CCD1: Construction Code Determination Form

Enter short description of Technical Topic (5 words or less): As-Built Fuel Oil Vault Construction

ZRD1/CCD1 Response Form

Fuel Oil Tank Room – Fire-Resistance Rating Assessment
55 Hudson Yards
New York, New York
Jensen Hughes Project No. 1ERL17004

Drawing Title
FUEL OIL TANK ROOM -
SECTION

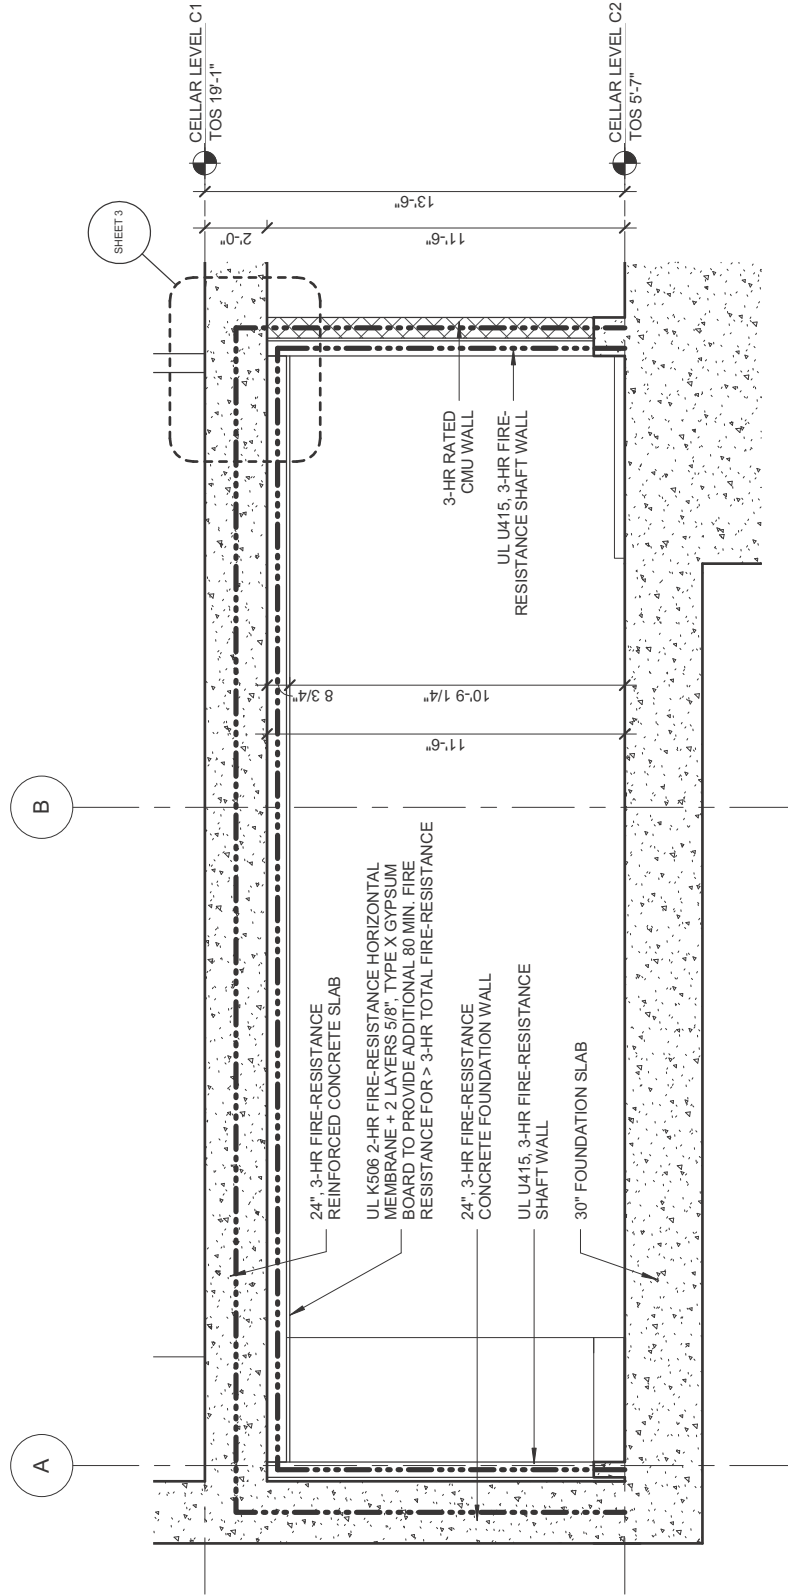
Referring to the sketches, the fuel oil storage is constructed with a 3 hour rated enclosure inside of a 3 hour rated room. The inner room is constructed of gypsum board. The ceiling assembly consists of a 2 hour rated membrane in accordance with UL K506. In-board of this assembly is a gypsum board assembly that provides an additional 80 minutes of fire resistance. The inner assembly is constructed in accordance with NYC BC 721.2.1.4(2). The overall assembly has a fire resistance in excess of 3 hours.

The outer ceiling is constructed of a 24" concrete slab and has a fire resistance rating of 3 hours. The outer walls are constructed of 8" concrete block and have a 3 hour fire resistance.

Finally, the applicant proposes to utilize an existing 24" concrete slab (The switchgear room) directly above the fuel oil tank room. This complies with the MC 1305.11.1.2(3) requirements for the building structure surrounding the fuel oil tank room. However, per Table BC 720.1(3), applicant must confirm at least 3/4" concrete cover on the rebar. In consideration of the above information, the proposed fuel oil tank room walls and ceiling and the existing adjacent structure comply with the New York City Construction Code fire resistance rating requirements. Therefore, the applicant's request is hereby approved with the following conditions:

1. Applicant must submit revised documents, to be verified by examiner, incorporating clarification on 24" slab directly above fuel oil tank room and the building structure surrounding fuel oil tank room, to ensure that at least a 3/4" concrete cover on rebar is provided in accordance with BC Table 720.1(3).
2. Applicant must utilize either System G or H of the selected UL design UL U415.

Date Created 06/05/2017
Project No.
Scale 1/8" = 1'-0"
Drawn By
Checked By
Drawing Title
FUEL OIL TANK ROOM -
PLAN

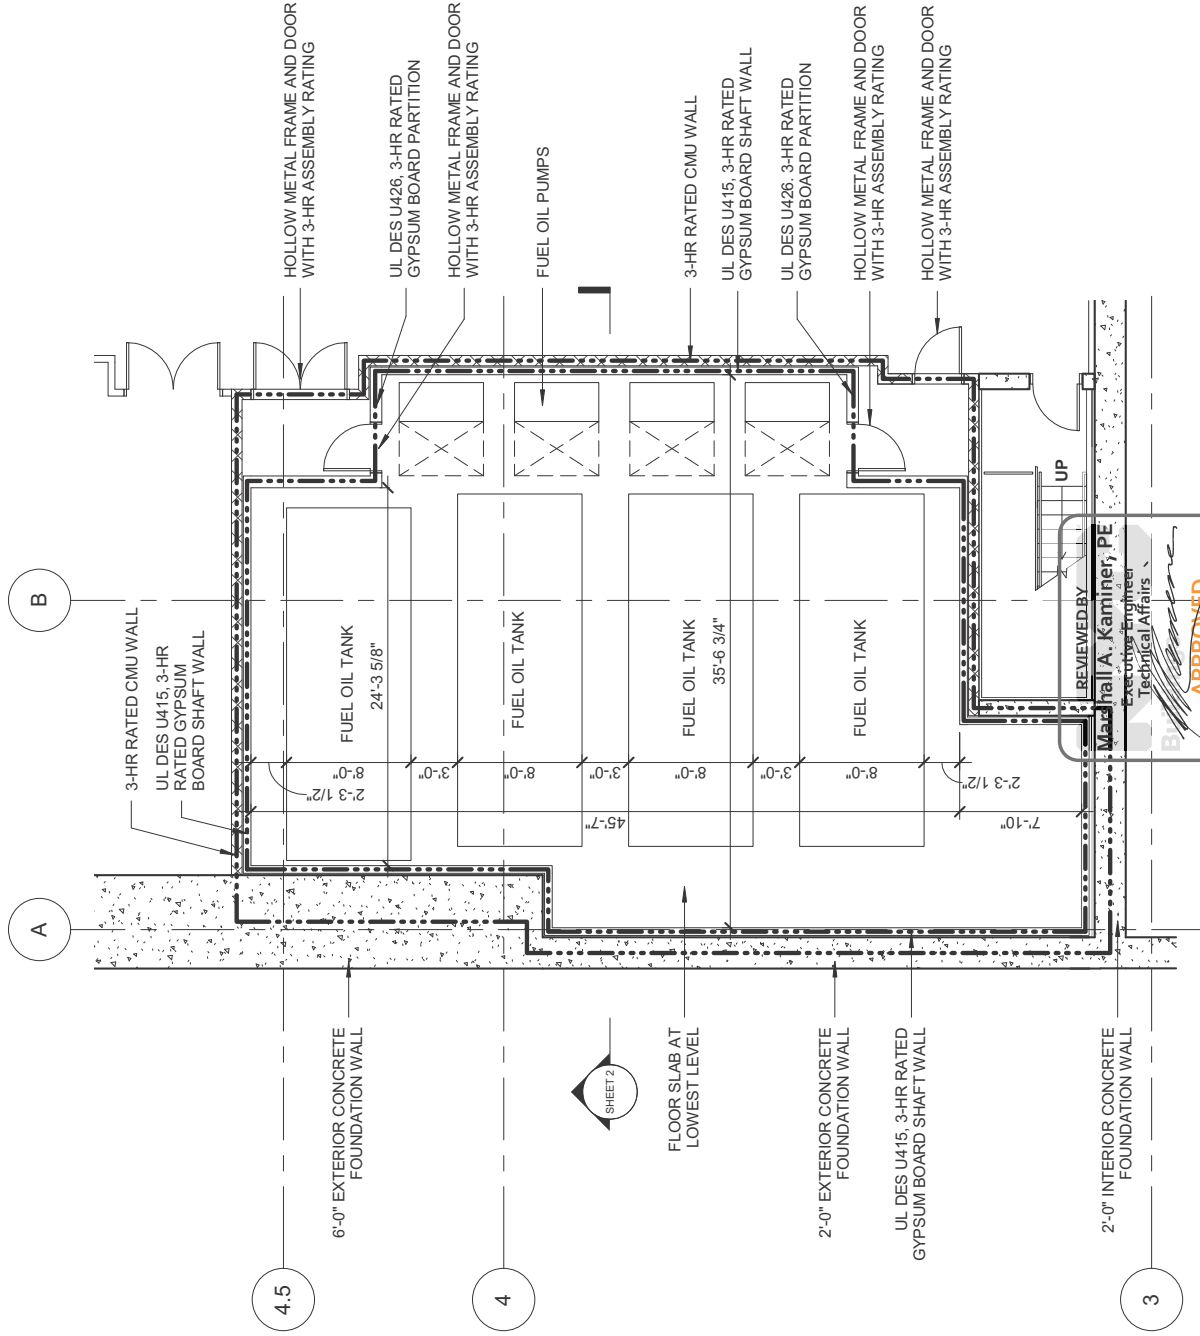
Access to the fuel oil room is through 2 vestibules. The inner and outer doors of the vestibule have a fire resistance rating of 3 hours. The doors and the vestibule walls maintain the continuous rating of a 3 hour inner enclosure fire resistance within a 3 hour outer room fire resistance.

The applicant also proposes walls for the fuel oil tank room. In compliance with MC 1305.11.1.2(3), the walls will be constructed of 3-hour fire resistance rated UL U415 System G or H designs. UL U415 is certified by UL in accordance with the test procedures set forth in standard UL 263 and is therefore in compliance with BC Section 703.2 requirements.

Date Created	06/05/2017
Project No.	
Scale	1 1/2" = 1'-0"
Drawn By	
Checked By	
Drawing Title	FUEL OIL TANK ROOM - WALL TO CEILING DETAIL

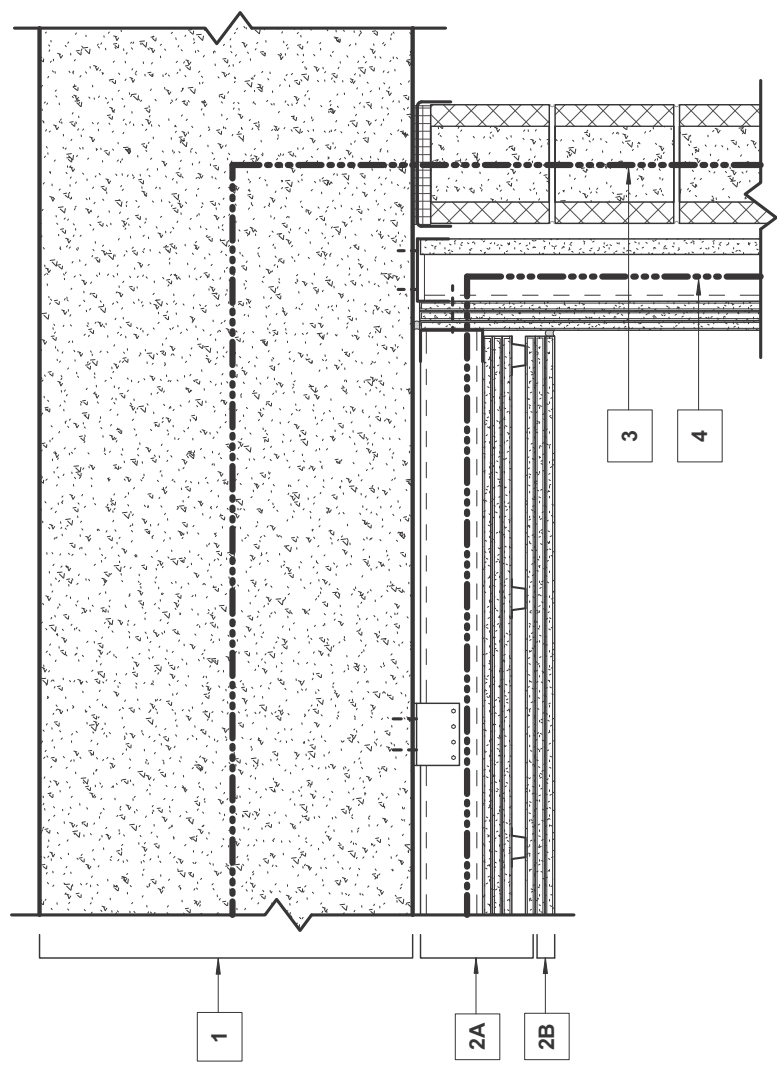
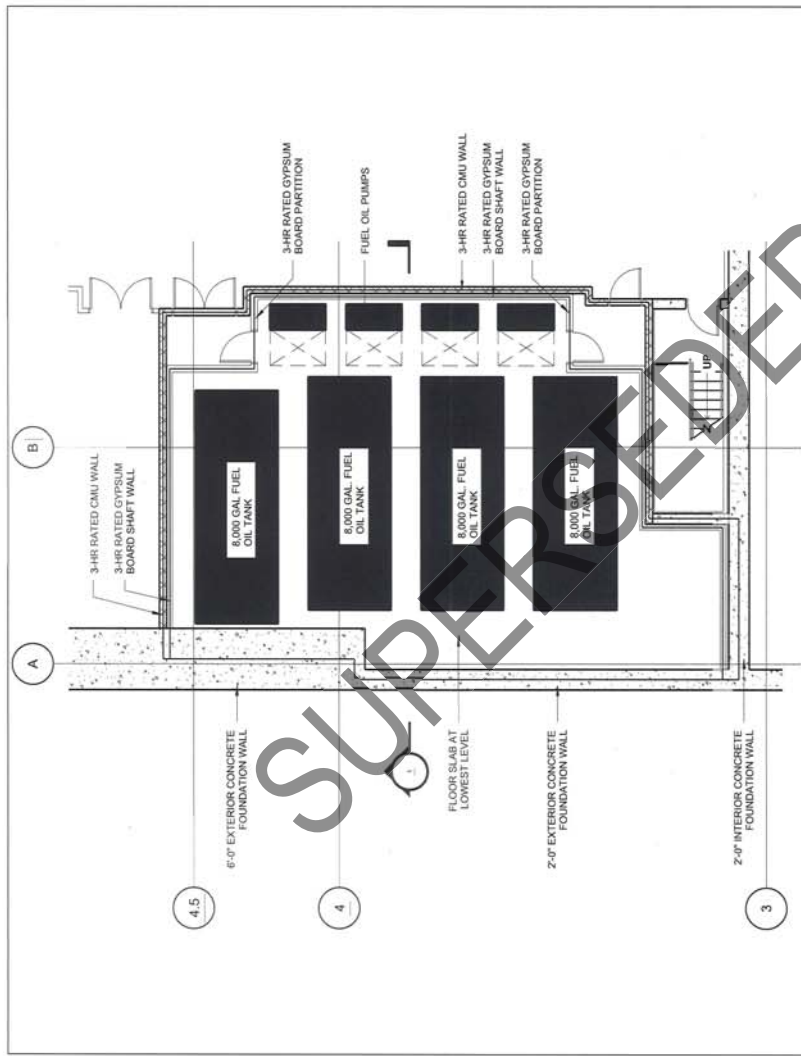
1. 24" 3-HR FIRE-RESISTANCE RATED REINFORCED CONCRETE SLAB - PRIMARY STRUCTURE.
- 2A. UL K506 2-HR FIRE-RESISTANCE HORIZONTAL MEMBRANE:
 - 4" x 1 5/8" 20 GA. STEEL STUDS @ 24" O.C.
 - (3) LAYERS 5/8" TYPE X GYPSUM BOARD
 - 25GA. 7/8" RESILIENT OR FURRING CHANNEL, 16" O.C.
 - (1) LAYER 5/8" TYPE X GYPSUM BOARD
- 2B. (2) LAYERS 5/8" TYPE X GYPSUM BOARD TO PROVIDE ADDITIONAL 80 MIN. FIRE RESISTANCE PER NYC BC 721.2.1.4(2)

3. 3-HR FIRE-RESISTANCE RATED, 8" CMU BLOCK WALL
4. UL DES U415 3-HR FIRE-RESISTANCE RATED SHAFT WALL
 - 1" GYPSUM LINER PANELS
 - 4" C-H STUD, 25GA @ 24" O.C.
 - (3) LAYER 5/8" TYPE X GYPSUM BOARD

The applicant proposes a ceiling assembly design UL K506, comprised of a triple layer of 5/8" Type X gypsum board attached to the 24" normal weight concrete structural slab with 20 ga 6" steel c-channels. A fourth layer of 5/8" Type X gypsum board is hung below using 26 ga 7/8" steel straps, 16" on center. Pursuant to NYC Building Code ("BC") Section 703.2, "The fire-resistance rating of building elements, components or assemblies shall be determined in accordance with the test procedures set forth in ASTM E119 or UL 263 or in accordance with Section 703.3." This proposed ceiling assembly design is certified by UL after testing to UL 263 standards and therefore provides a two-hour fire resistance rating that meets BC 703 requirements.

Pursuant to the BC 721.2.1.4(2) table of fire resistance ratings, the proposed installation of an additional pair of 5/8" Type X gypsum board layers directly to the underside (face of fire exposure) of the UL K506 ceiling assembly will add 80 minutes to the required 2 hour rating of the ceiling assembly.

Figure No. 1: Fuel Oil Tank Room – Plan View

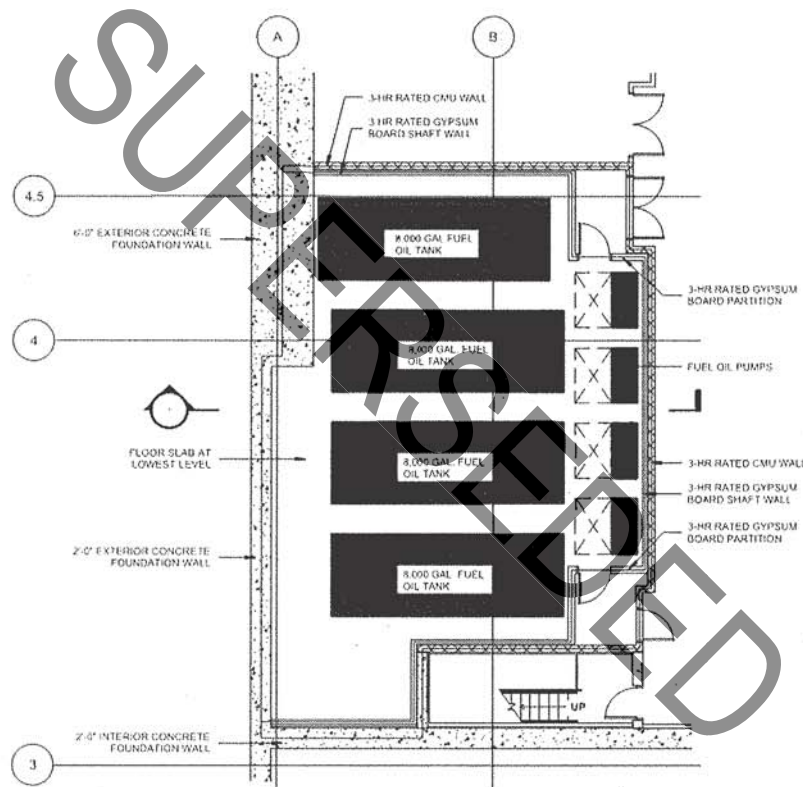
- North wall and East wall – Comprised of a 3-hour fire-resistance rated gypsum board shaft wall on the interior (room) side, with a 3-hour concrete masonry unit (CMU) wall located immediately adjacent to the gypsum board shaft wall (i.e. the shaft wall is between the fuel oil tank room and the CMU wall). Vestibules are provided in the northeast and southeast corner of the room. The vestibules are located between the gypsum board shaft wall and the CMU wall. The CMU wall is part of the building structure. The gypsum board shaft wall is not part of the building structure.

- South wall (east) – Similar to the North and East walls, a combination of a 3-hour fire-rated gypsum board shaft wall and a 3-hour fire-rated CMU wall separate the fuel oil tank room from a stair enclosure. The CMU wall is part of the building structure. The gypsum board shaft wall is not part of the building structure.

The wall assemblies around the fuel oil tanks appear to be compliant with vault requirements of NYCMC Section 1305.11.1.2 Item 3.

Figure No. 2: Fuel Oil Tank Room – Section View

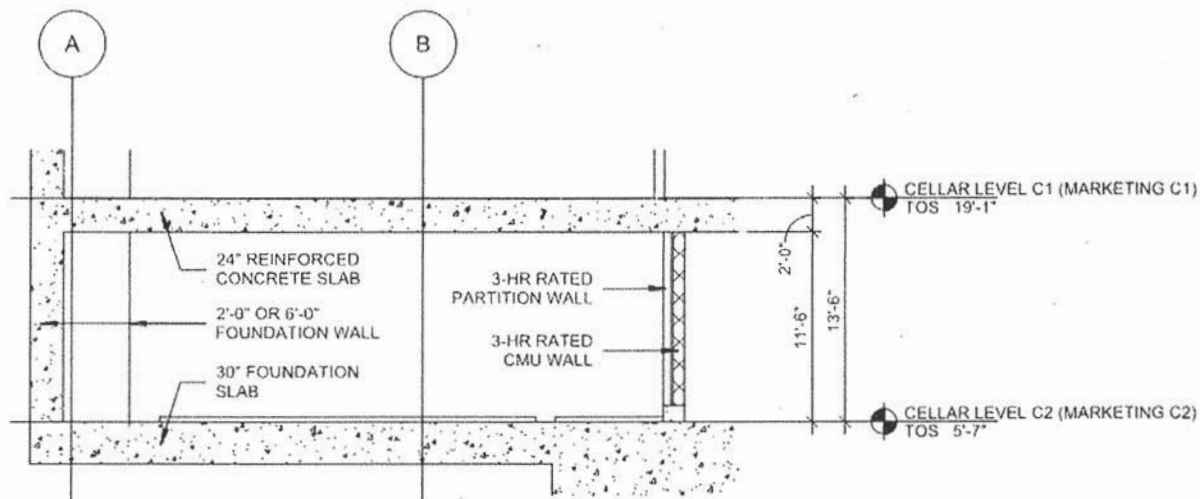
The ceiling assembly in the fuel oil tank room is a 24-inch thick reinforced concrete slab. The slab is 6,000 psi normal weight concrete and was designed to support the switchgears and other electrical equipment on the floor above. The ceiling assembly is part of the building structure. See Figure No. 2 for a section view of the fuel oil tank room, prepared by WSP | Parsons Brinckerhoff, showing the ceiling assembly.

Regarding the ceiling assembly, the design proposes to use the 24-inch thick ceiling slab of the fuel oil tank room as both the vault enclosure and room protection. The vault is required to provide a 3-hour fire-resistance rating and the room protection is required to provide a 2-hour fire-resistance rating. The 24-

inch thick concrete floor slab provides well in excess of the cumulative 5-hour fire-resistance rating provided by these components.

Figure No. 4: Fire-Resistance Rating for Siliceous Concrete

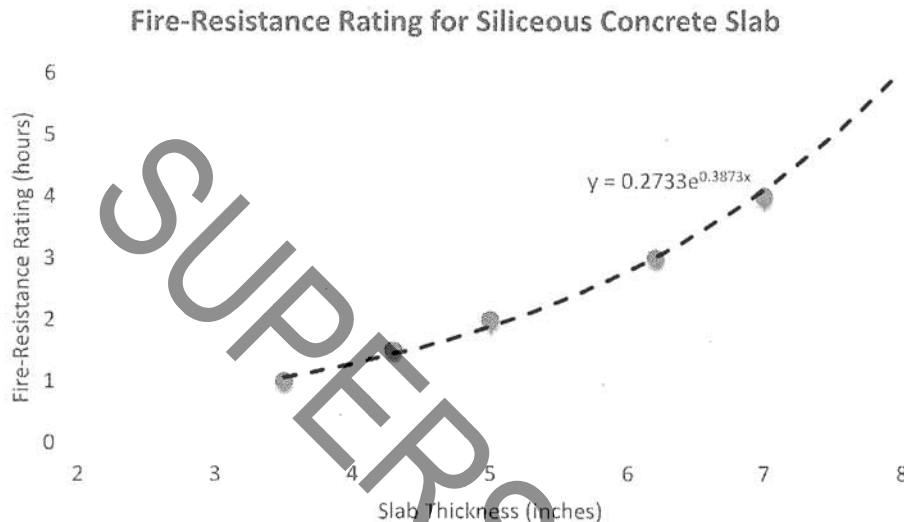
The required concrete slab thickness is identified in Table 721.2.2.1 for 1-hour, 1.5-hour, 2-hour, 3-hour and 4-hour fire-resistance ratings. The fire-resistance rating increases exponentially with the thickness of concrete slab provided. The relationship between slab thickness versus hourly fire-resistance rating is presented in Figure No. 4.

Considering the cumulative required fire-resistance rating of five (5) hours, a 7.6-inch slab would adequately provide this rating. As slab thickness increases above eight (8) inches, there is a diminishing return on fire-resistance due to the exponential relationship and lack of data points beyond four (4) hours.
